22-COA-0251

**2354, 2356, 2358 Grinstead Dr.
& 2421, 2423 Glenmary Ave.**

**Cherokee Triangle Architectural Review Committee
Public Hearing**

**Bradley Fister, Planning & Design Coordinator
November 30, 2022 continued to March 8, 2023**

Conceptual Parking Lot Site Plan

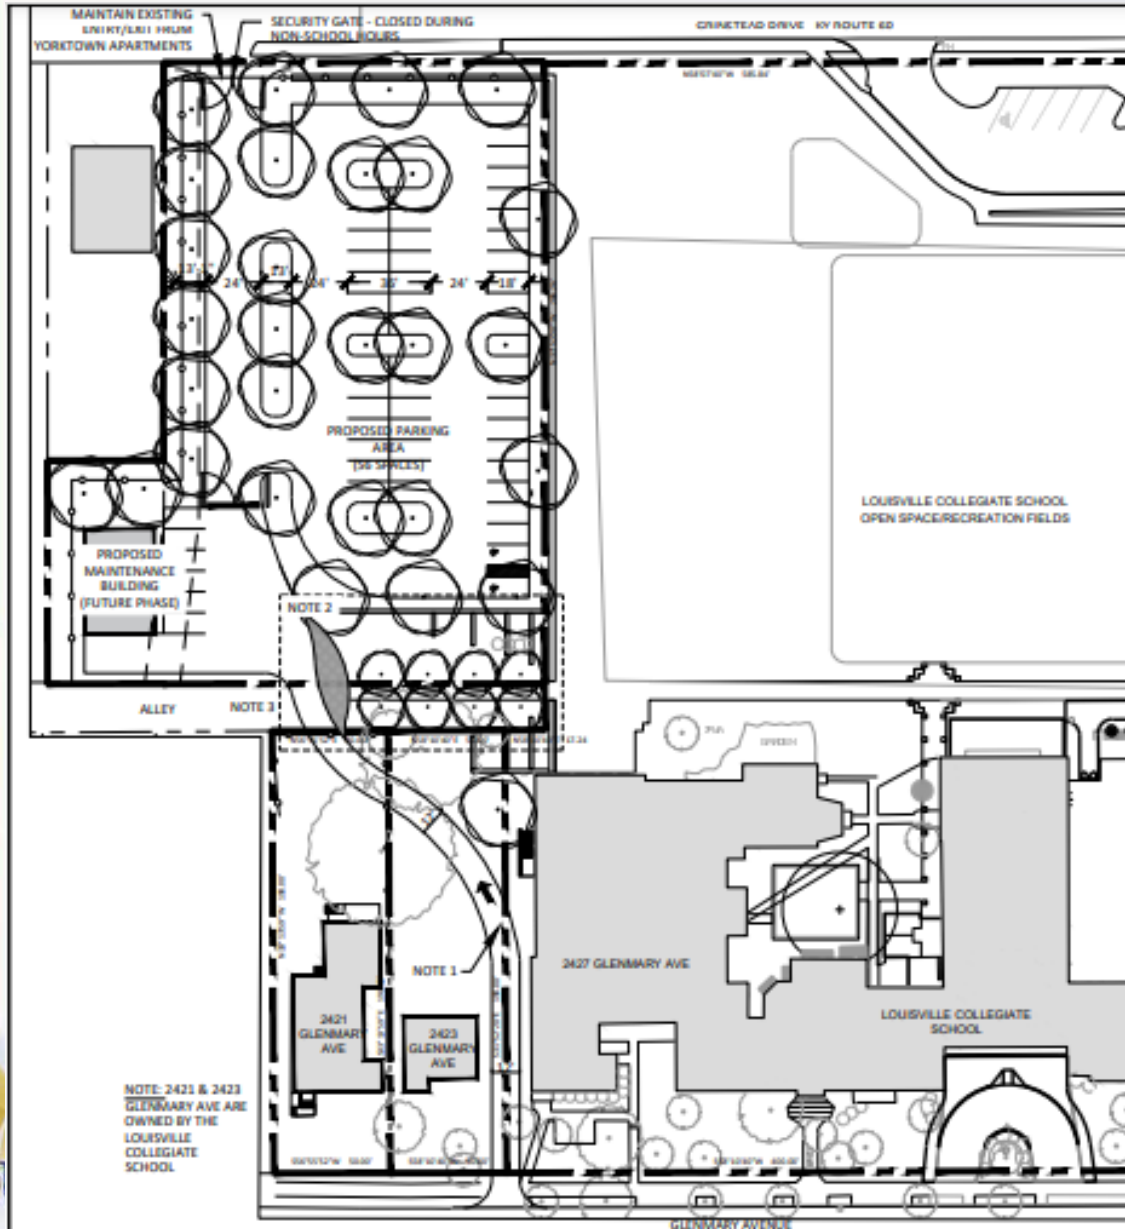
- The applicant proposes to demolish three, two-story, circa 1960 apartment buildings to create a parking lot. The proposed parking lot is to provide off street parking for the Louisville Collegiate School and would be accessible from the existing ingress/egress to the apartment complex along Grinstead Dr.
- This parking lot is part of a larger, conceptual plan to relieve traffic strain on Glenmary Ave. While the plan is still conceptual at this time, it shows a new driveway off Glenmary Ave. that flows traffic to the proposed new parking lot with access to Grinstead Dr.

- 1. The existing buildings shall not be demolished until all parking lot approvals are issued, and a Kentucky Historic Properties Survey Form has been submitted to staff and the Kentucky Heritage Council.**
- 2. The applicant shall notify staff of an excavation schedule for the site and if/when archaeological discoveries such as artifacts, features, and other archaeological deposits are found during demolition and construction of the parking lot**

- 3. Final landscaping details shall be submitted to staff for review and approval. The plan must include the parking lot and show proposed and existing trees and landscaping. A copy of the LDC required Landscape Plan will suffice.**
- 4. Any proposed screening walls, fencing, gates, etc. shall be submitted to staff for review and approval prior to construction.**
- 5. Prior to installation, final exterior lighting fixture details shall be submitted to staff for review and approval and shall include cut sheets for all exterior lighting fixtures.**

- 9.** Once the applicant finalizes the conceptual traffic plan, they shall submit it to staff for review and final approval prior to work taking place. Additional COA applications may be required.
- 10.** If the design or scope of the project changes in any way, the applicant shall contact staff for review and approval.
